Moreland
City Council

COUNCIL AGENDA

Wednesday 28 September 2022

5.1 170 SYDNEY ROAD, COBURG - PLANNING APPLICATION NO.
MPS/2021/868

Figure 1 – Sydney Road streetscape elevation showing street wall. Source: Dwg TP200

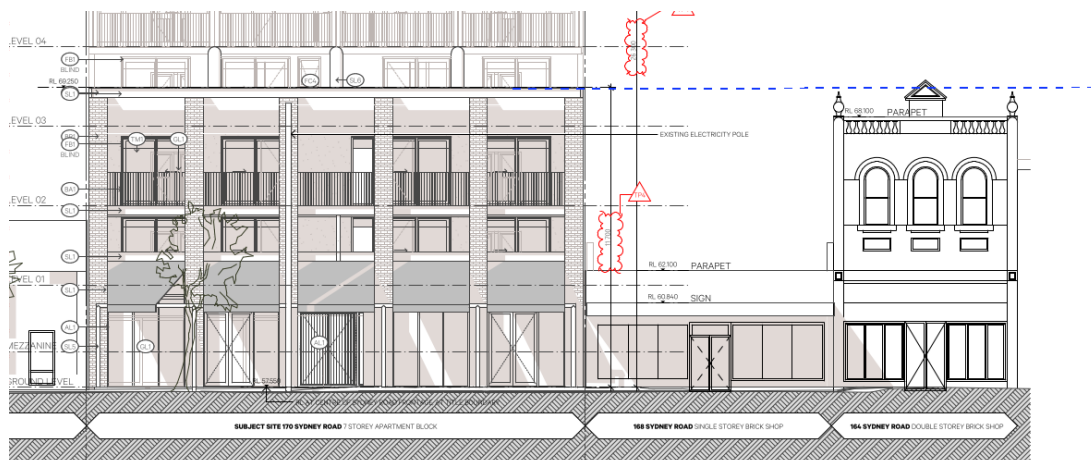
The minor street wall variation is acceptable as the three-storey podium would define the street edge and retain a pedestrian-friendly human scale to Sydney Road. The street wall responds to the character and scale of the significant heritage buildings to the south at 164 Sydney Road, with a comparable street wall height sitting below the central pediment detail of this important building (see Figures 1 and 2 below).

Figure 3 – Perspective view taken from north-east of the Site on Rennie Street, including massing of potential ACZ-compliant future development at No. 182 Sydney Road. Source: Kennedy Nolan

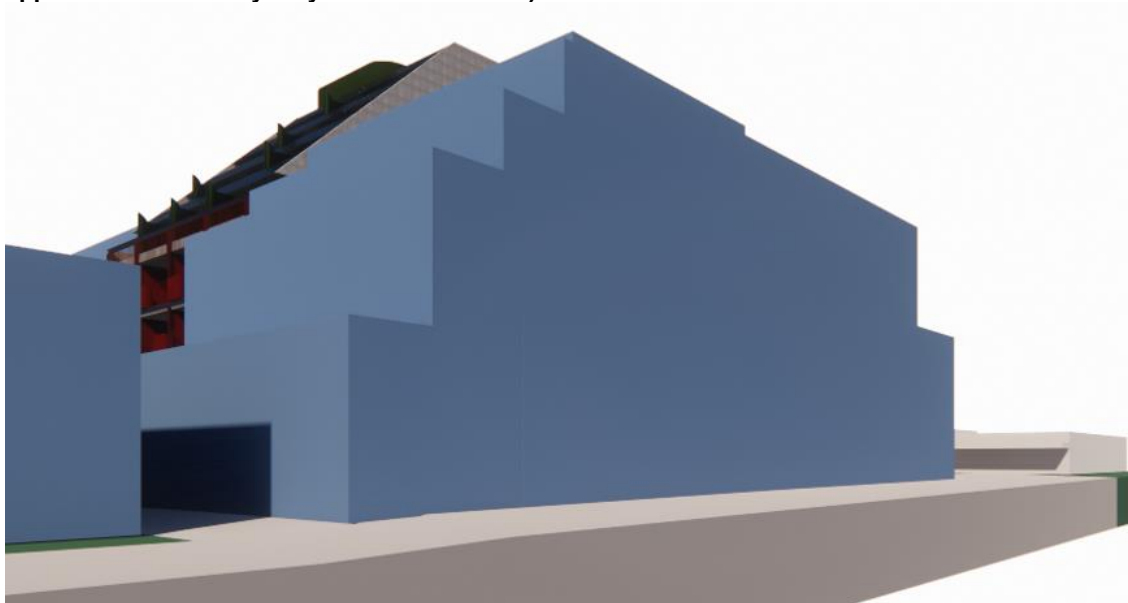
Notwithstanding the above, it is considered the pergola at rooftop terrace level can be reduced in area or modified in siting so as to have its visibility from the public realm reduced. 3D perspectives demonstrate this structure will be visible from eye level on Sydney Road. Reducing its visibility will assist in mitigating the visual impact of the proposed development.

- b) The Level 7 pergola in the communal rooftop terrace reduced in area and/or sited further back from the Sydney Road frontage to reduce its visibility from the public realm.
